**VILLAGE OF ALGONQUIN
PLANNING AND ZONING COMMISSION
AGENDA**

SUBJECT: *Case No. 2019-15. 2621 Corporate Parkway — Final Planned Unit Development*

Subject: 2621 Corporate Parkway – FIRST REVIEW
Algonquin Case No. 2019-15
(CBBEL Project No. 07-0272.00118)

DATE: September 27, 2019
TO: Ben Mason, Senior Planner Village of Algonquin
FROM: Cory Pikora, Fire Prevention Director Algonquin- LITH FPD
RE: 2019-15 Final PUD 2621 Corporate Parkway

SITE PLAN
ALGONQUIN CORPORATE CAMPUS LOT #2
ALGONQUIN, ILLINOIS

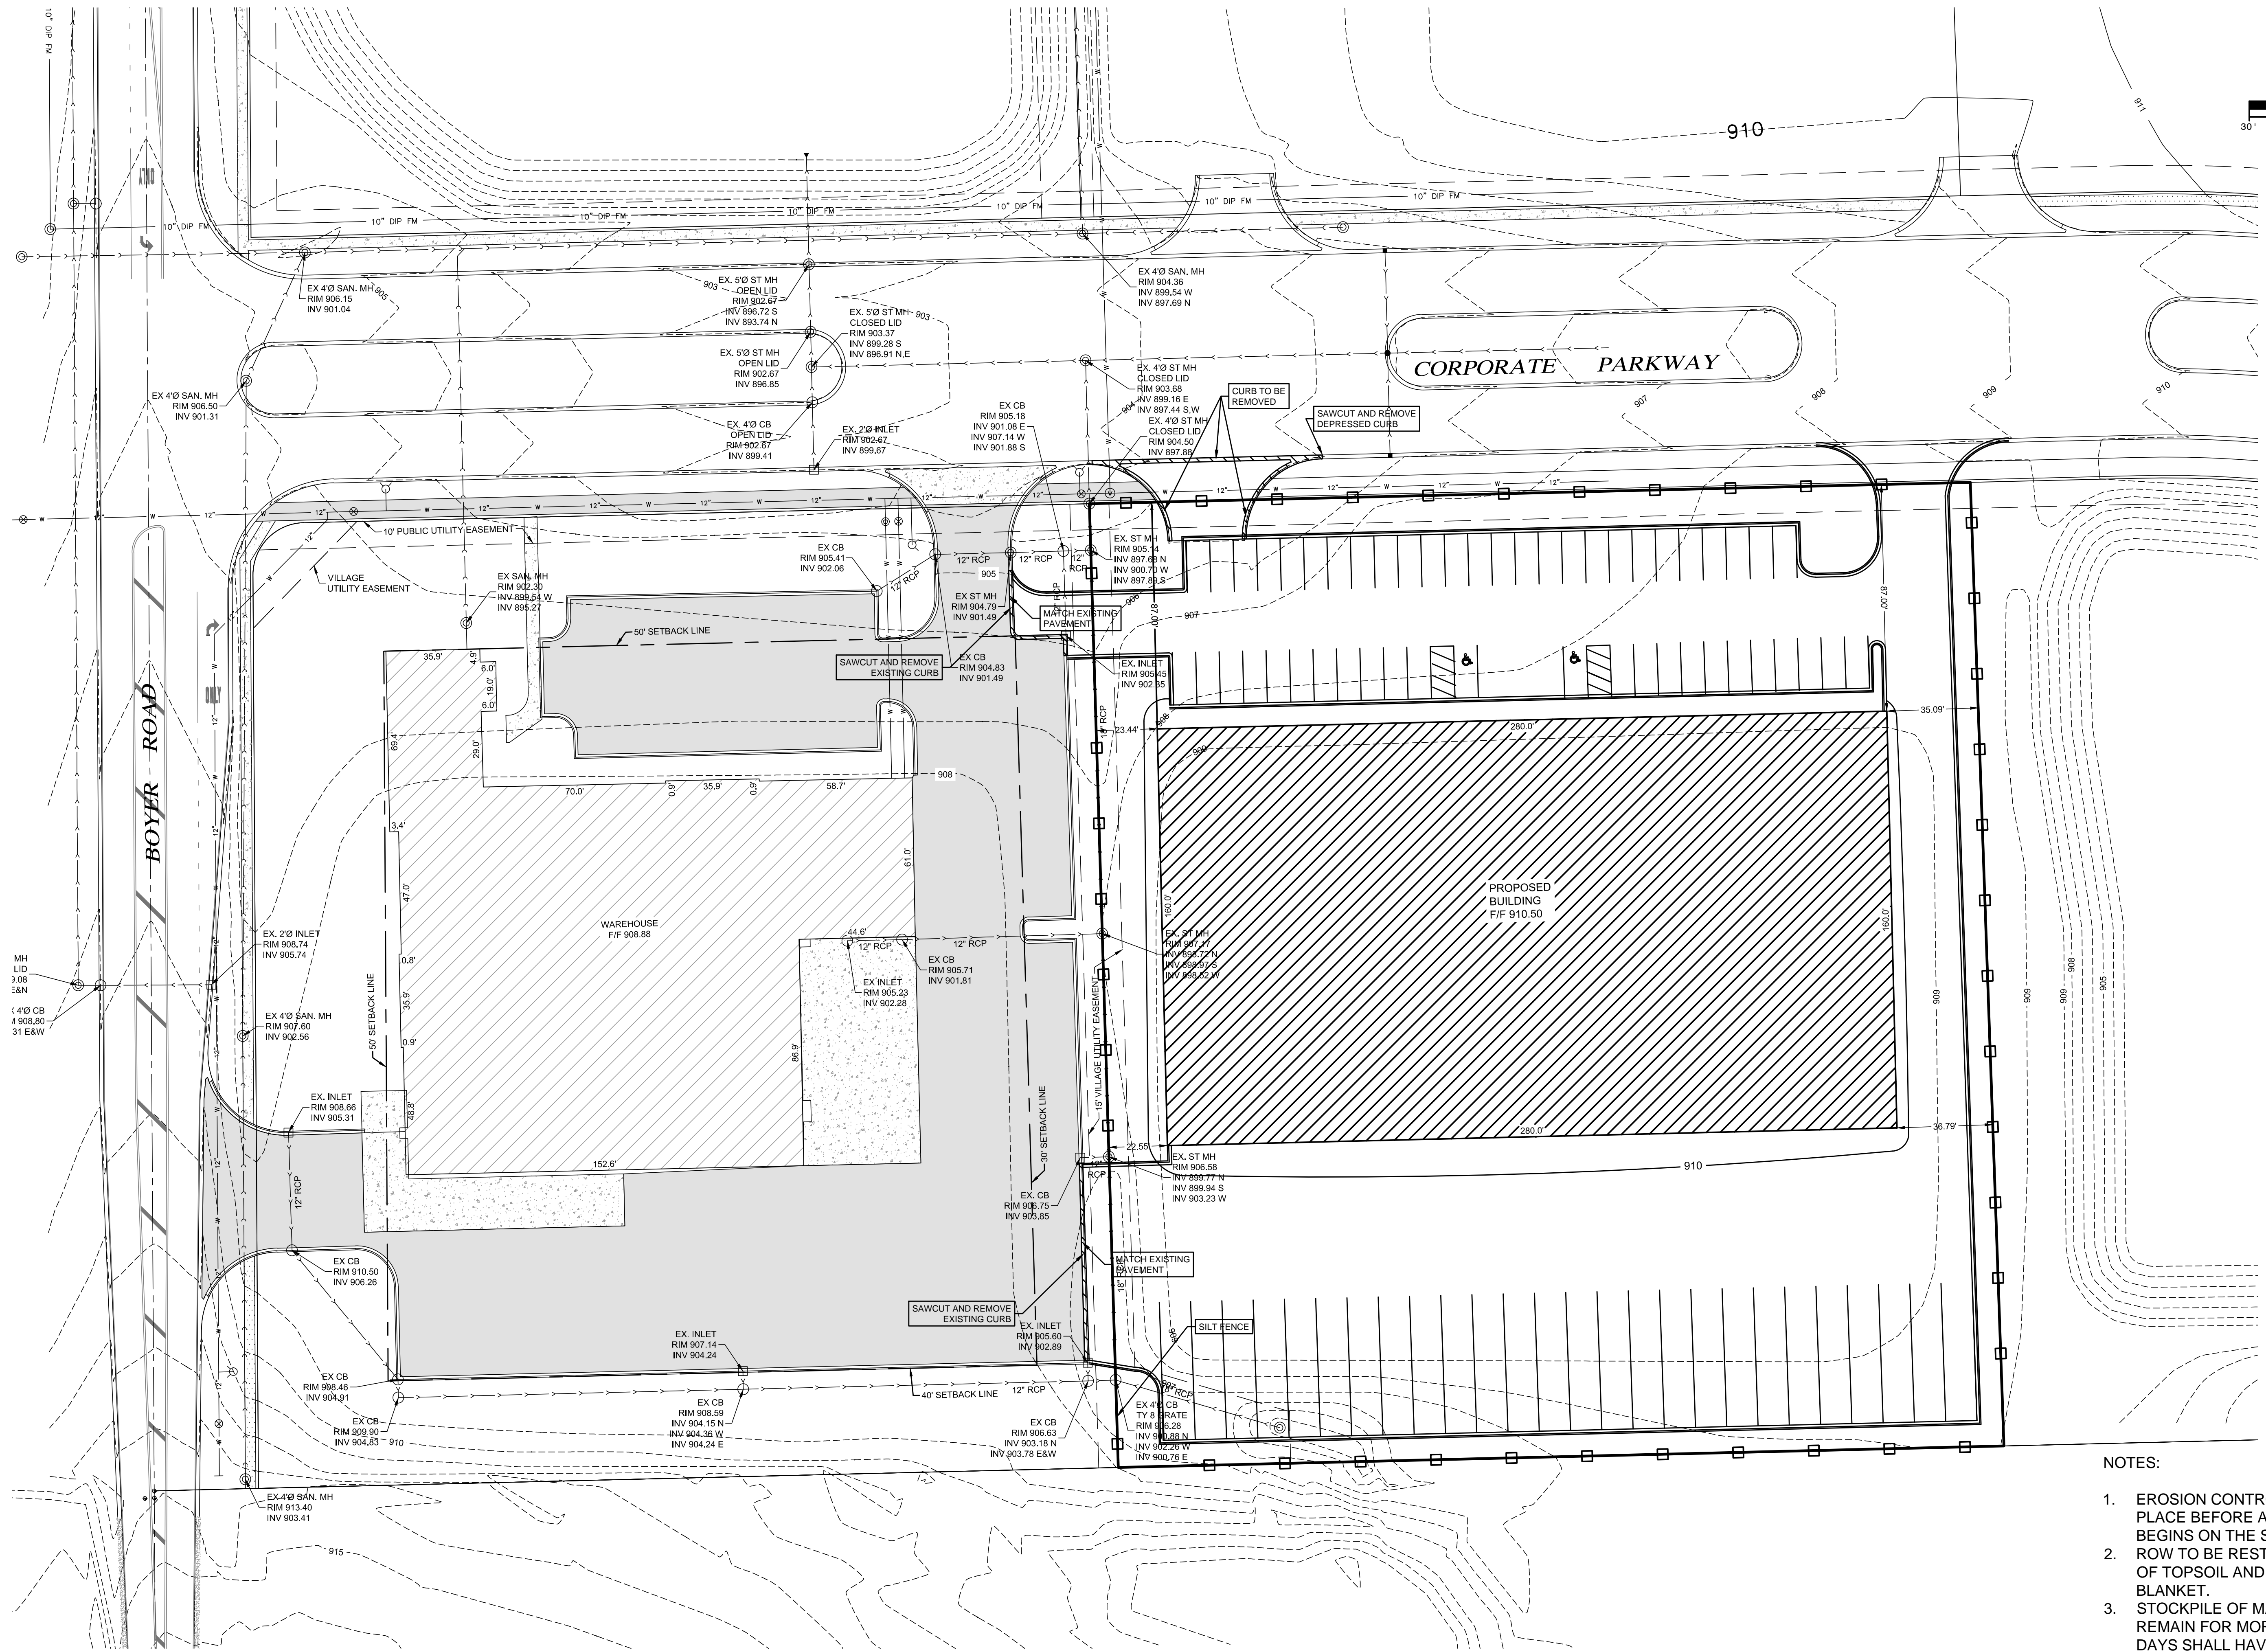
The submitted “engineering” plan is really a rudimentary site plan with very little site engineering information provided. We have identified the following that should be included in the next engineering submittal.

- Temporary soil stockpiles
6. The engineering plans shall include all applicable specifications and standard details for the pavement, utility, and SESC components applicable to this project.
 7. The existing trees in the south parkway of Corporate Parkway are missing from the plan sheet.
 8. If there will be employees moving back and forth between the two buildings, then we recommend that a dedicated pedestrian walkway be designed into the improvements. One location that could be used is the pavement narrowing where there is an existing parking island along the east side of the parking area of the existing building.
 9. There is an existing fire hydrant along the south side of Corporate Parkway near the eastern boundary of the development site that is not noted on the plan sheet and could be impacted by the construction of the proposed driveway.

10. The proposed Site Plan does not indicate the proposed lighting. Please identify the standalone lighting unit locations on the Site Plan and Utility Plan when it is Resubmitted.
11. The site geometry depicted on the Photometric Plan does not match the geometry as shown on the proposed Site Plan. Please revise the Site Plan and Photometric Plan accordingly.
12. The Landscape Plan shows trees that are conflicted with the standalone lighting units. Please revise Photometric and Site Plans accordingly.
13. On the Photometric Plan, there are no calculation points shown in the adjacent parking lot to the West of the building. Please provide a Calculation Grid that is all encompassing of all parking areas and drive aisles.

19. There is a depressed area at the southwest corner of the site that is served by an existing storm structure. There is no elevation information provided for the structure and the surrounding contours are not numbered. This off-site flow will need to be accommodated with the engineering for the project.

- Indicate the fire hydrants locations on the drawing. **IFC 508.1**
- Fire hydrants shall be no further than 300 feet apart, all hydrants shall not be on a dead end and shall be looped. **F 903.6 Yard Hydrants.**
- Indicate the water main size provided for the fire sprinkler system.
- Provide an emergency vehicle access plan using the turning radius schematic provided for our tower ladder truck. This access plan should include all driveways / roadways of the property. **IFC 503.2.4 Turning Radius**
- Fire Department hose access shall be no more than 150 feet from the fire apparatus to all sides of the buildings from each of the fire department access road. **IFC 503.1.1**

- All fire department access roads shall be a minimum of 20 feet of unobstructed width and 13'6" of unobstructed height. **IFC 503.2.1 Dimensions**
- Confirm the canvas awnings do not protrude into the fire department access roads.

- Mark the East, West, and South curb lines adjacent to the building as "No Parking Fire Lane" with either fire lane signage or paint and mark the curb line "No Parking Fire Lane" It is unclear if the West side of the building will have parking located in this area. The fire lane can be removed from the West side of the building should this area include parking. **IFC 503.3 Marking**
